Subject: **ADDENDUM NO. 7**

Project: **CENTER FOR MATERIALS AND MANUFACTURING SCIENCES, TROY UNIVERSITY MAIN CAMPUS-TROY ALABAMA**

Job #: **SSL# 18144**
BC# 2020416
PSCA#: 006P

Sheet Number:
A2.3a

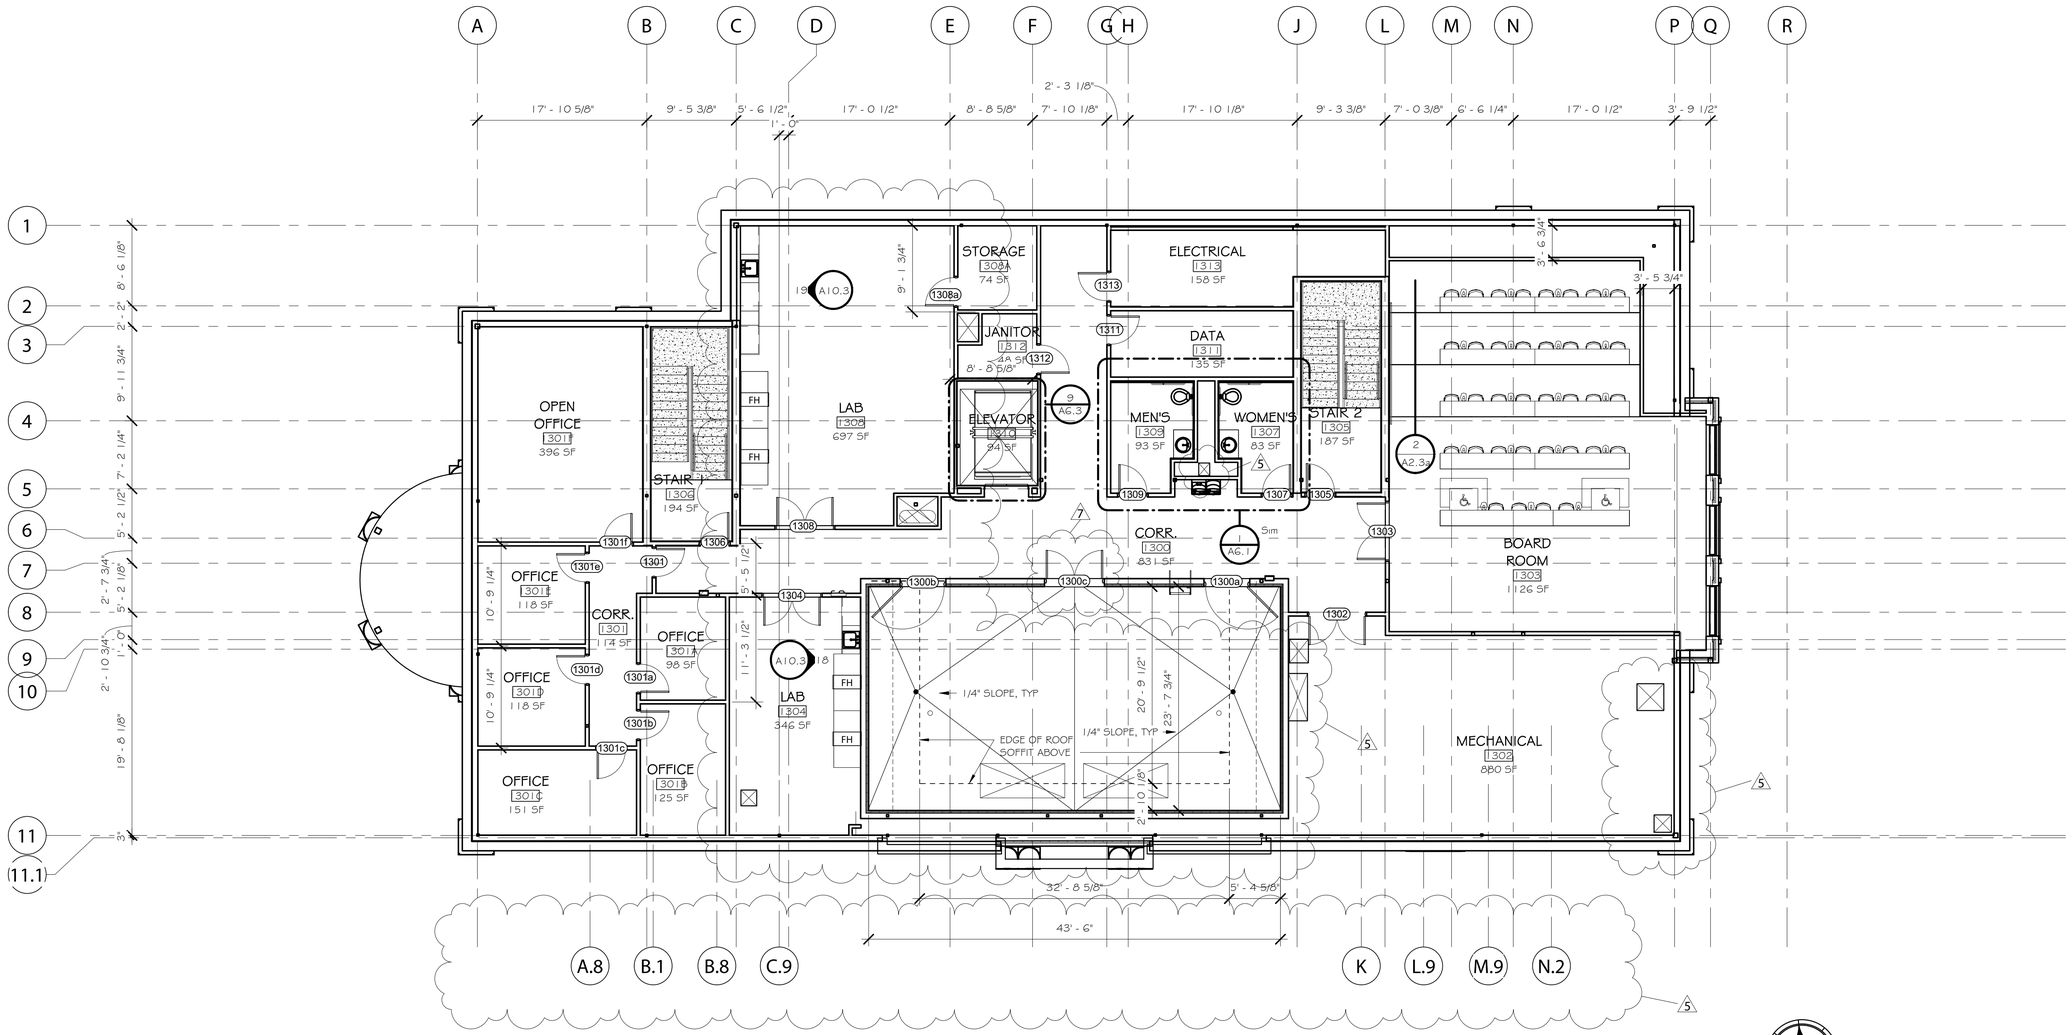
Item 7: Replace A2.3a with the attached A2.3a:
-Add door 1300c

Sheet Number
A4.1a

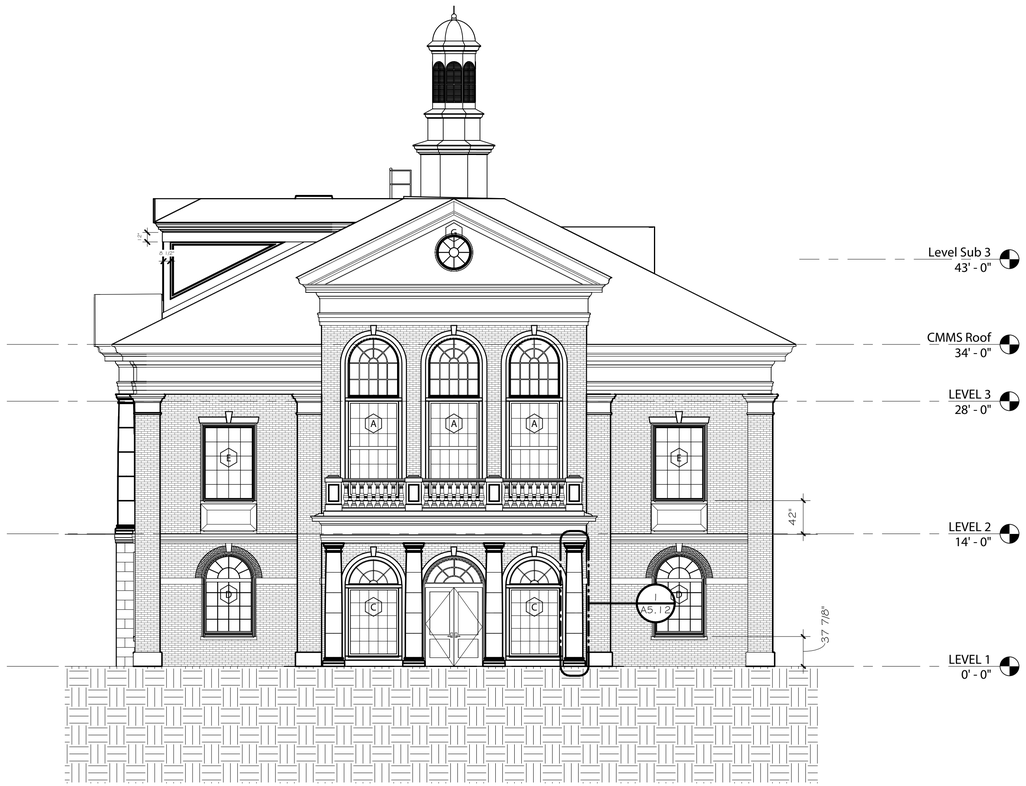
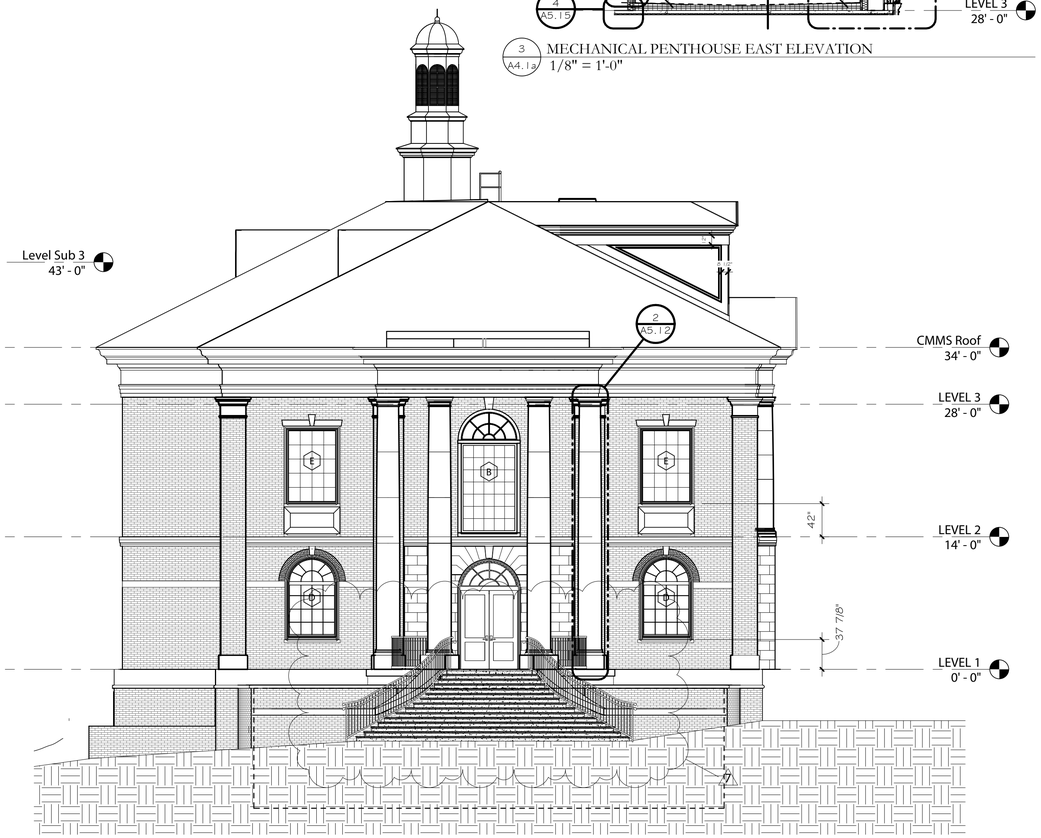
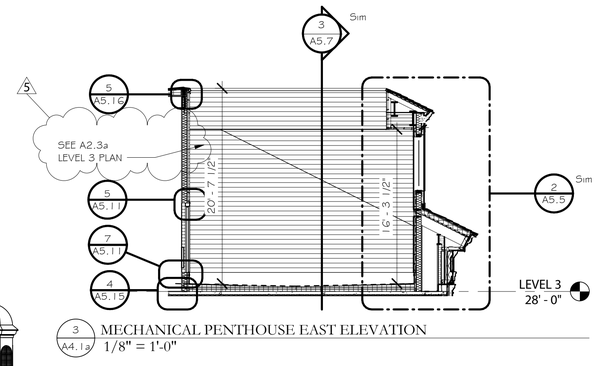
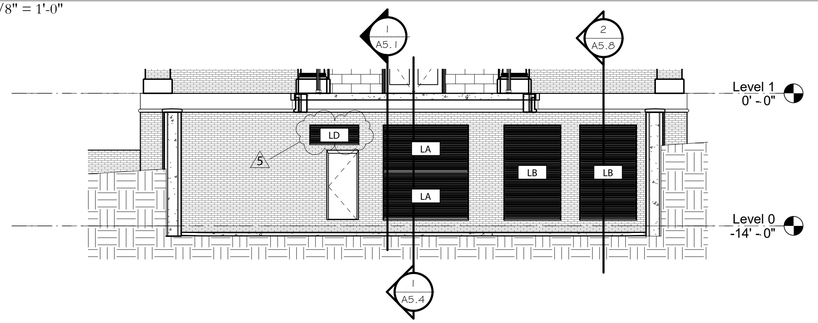
Item 9: Replace A4.1a with the attached A4.1a:
-Revise West stair elevation

Sheet Number
A4.2

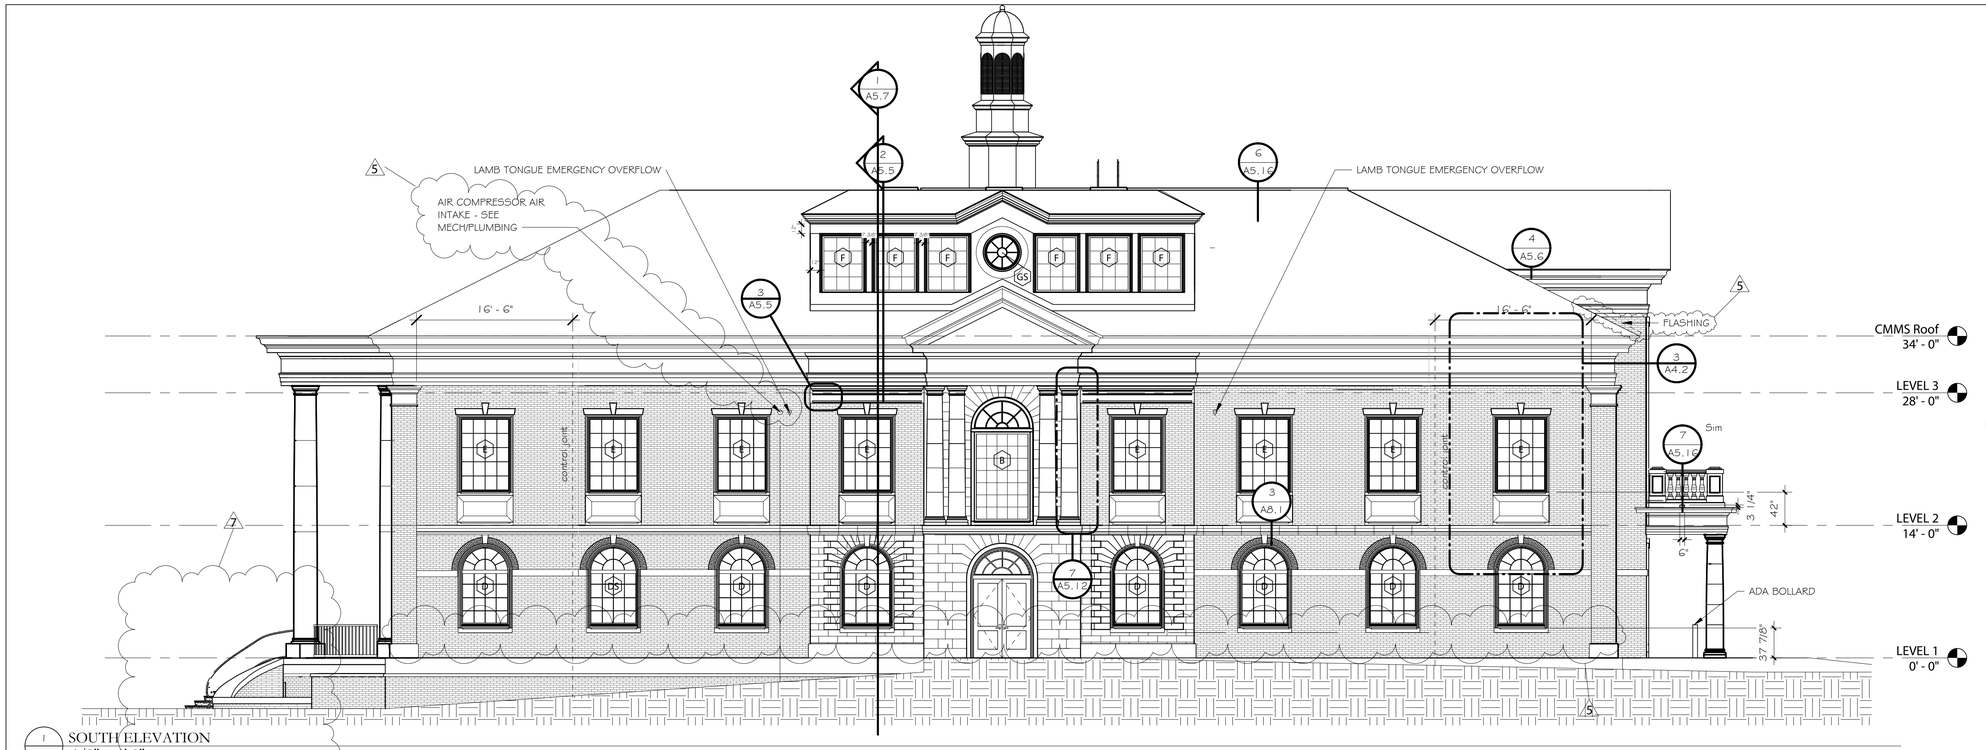
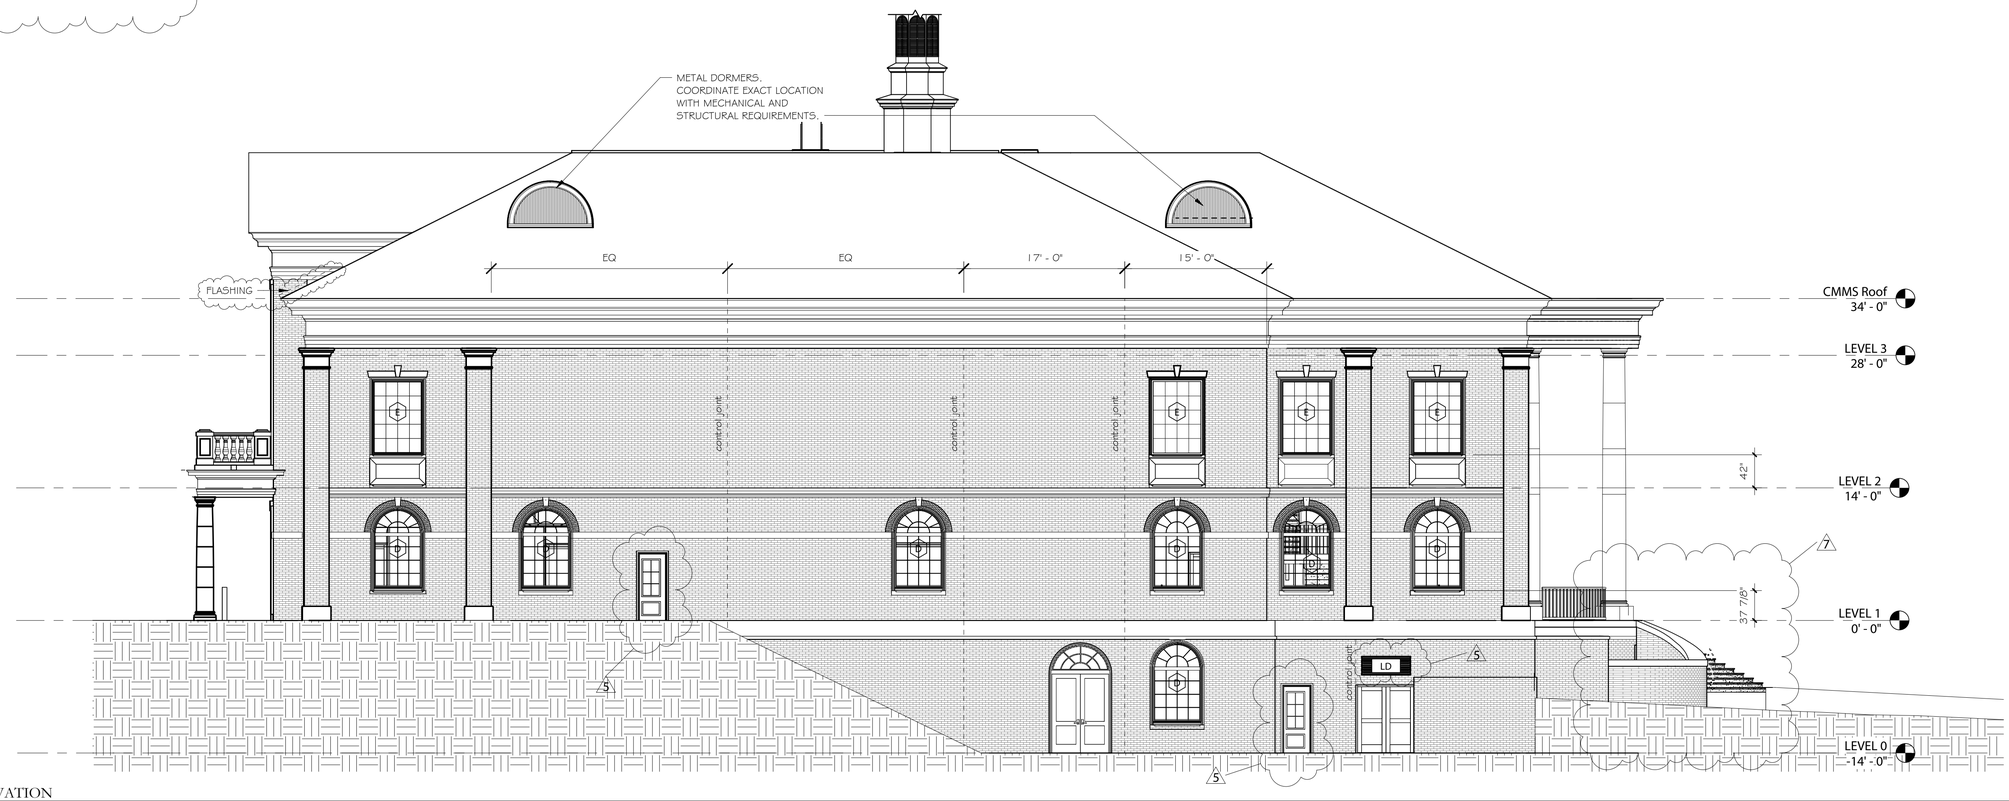
Item 10: Replace A4.2 with the attached A4.2:
-Revise West stair elevation

Sheet Number
A5.4

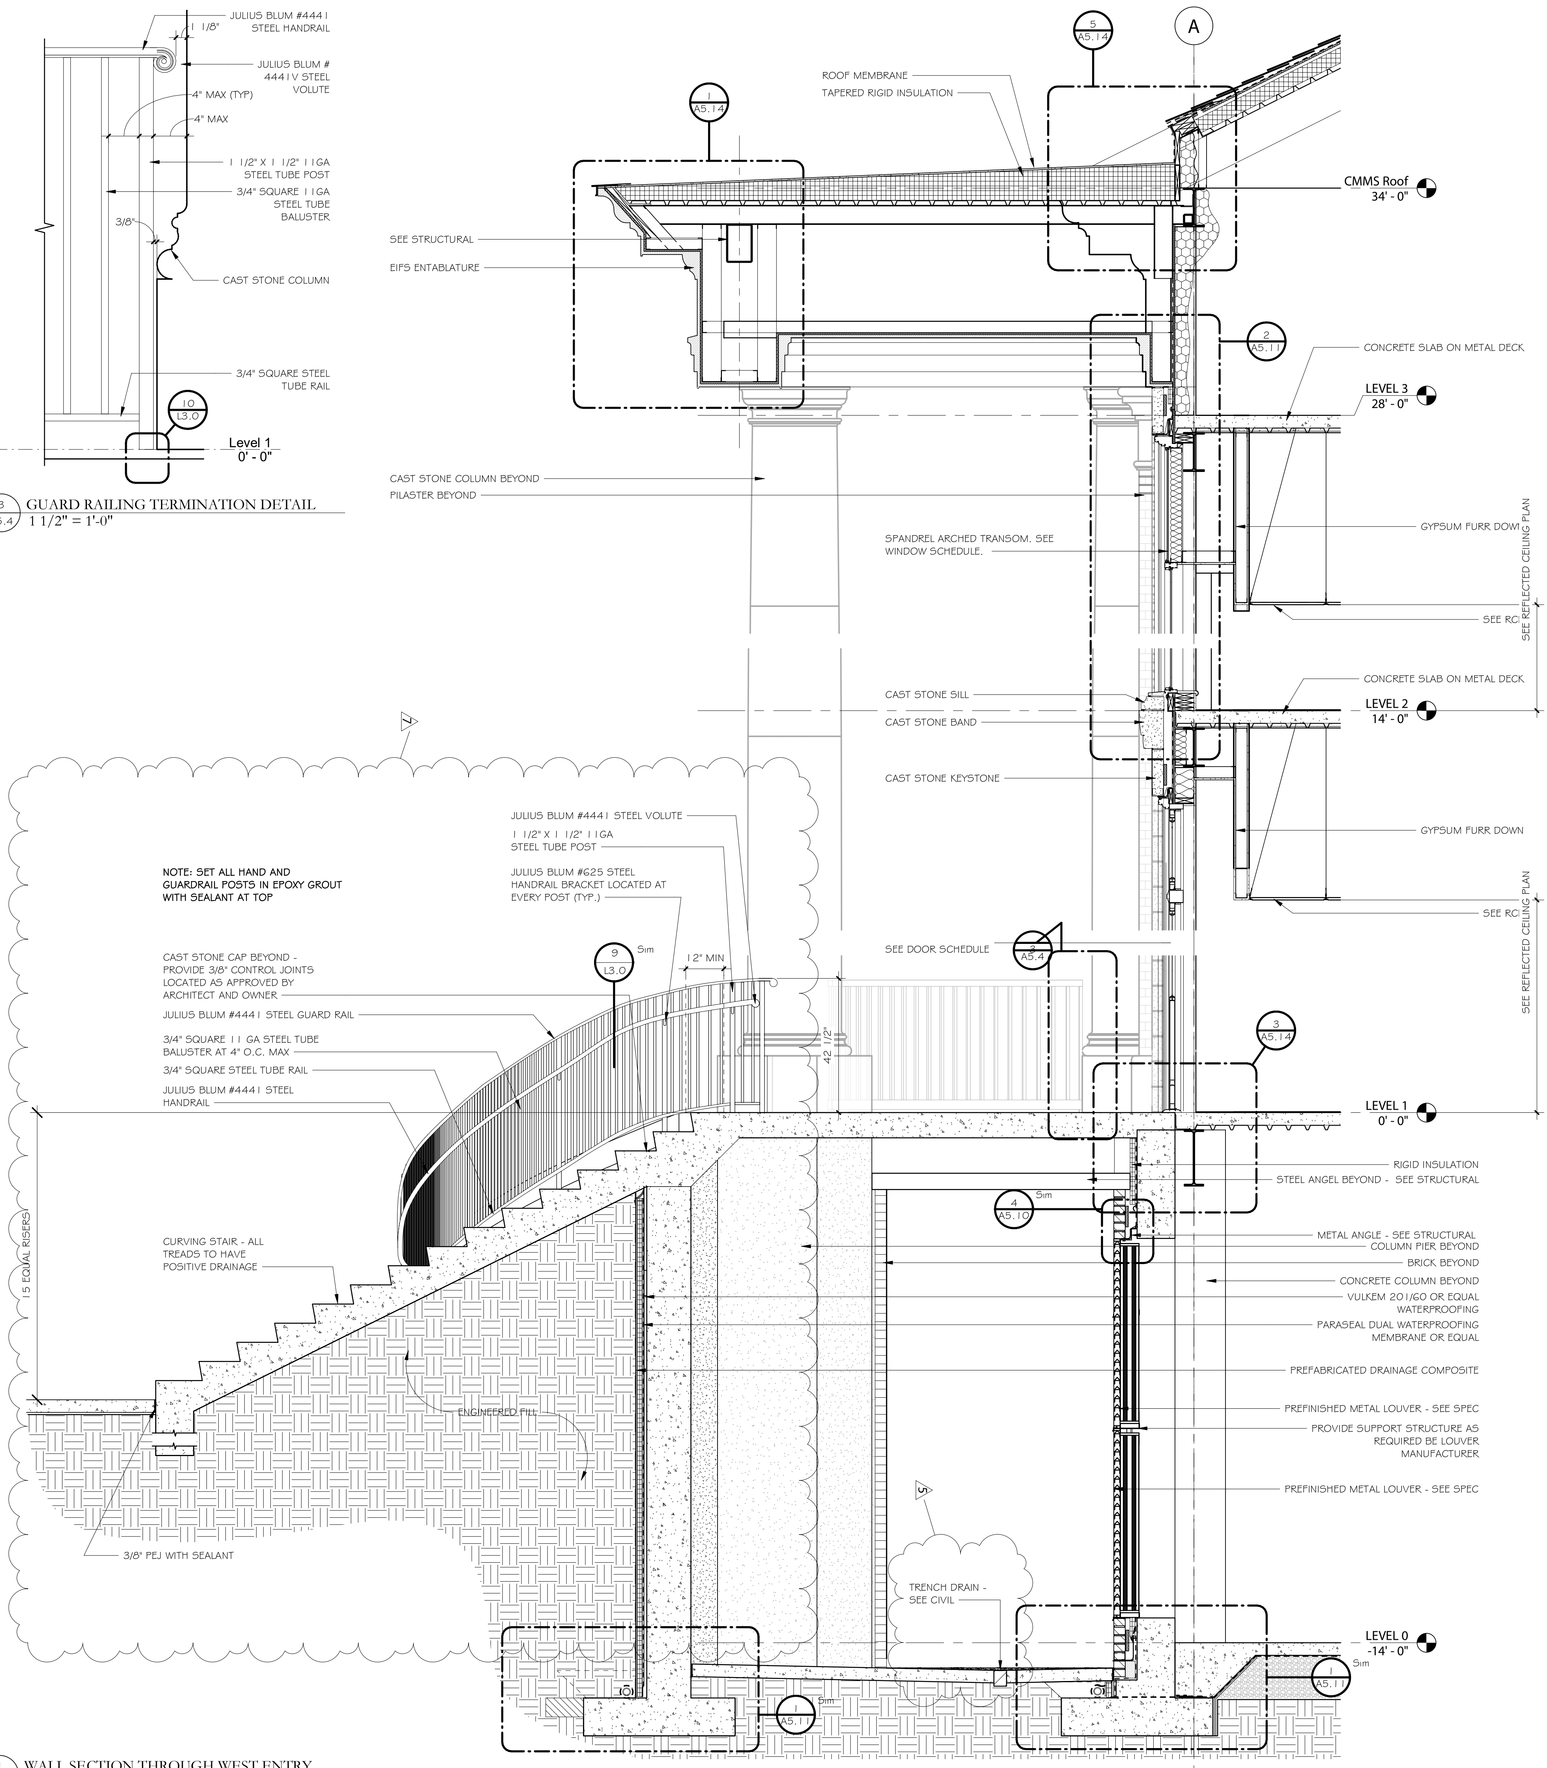
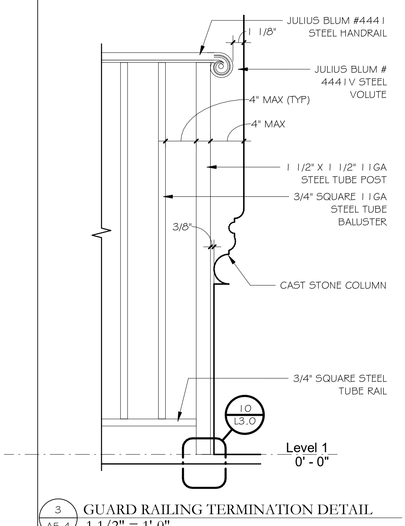
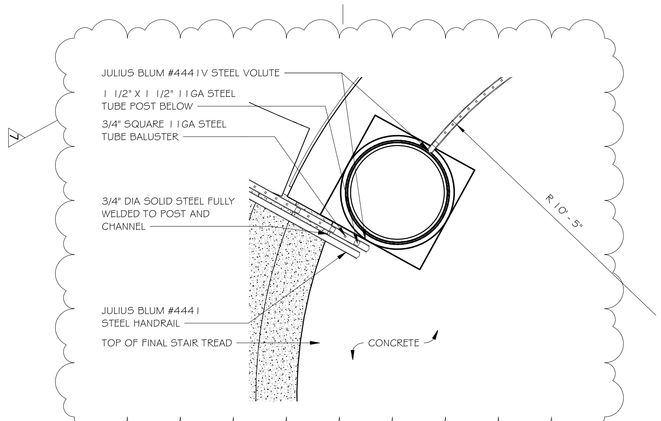
Item 11: Replace A5.4 with the attached A5.4:
-Revise West stair section
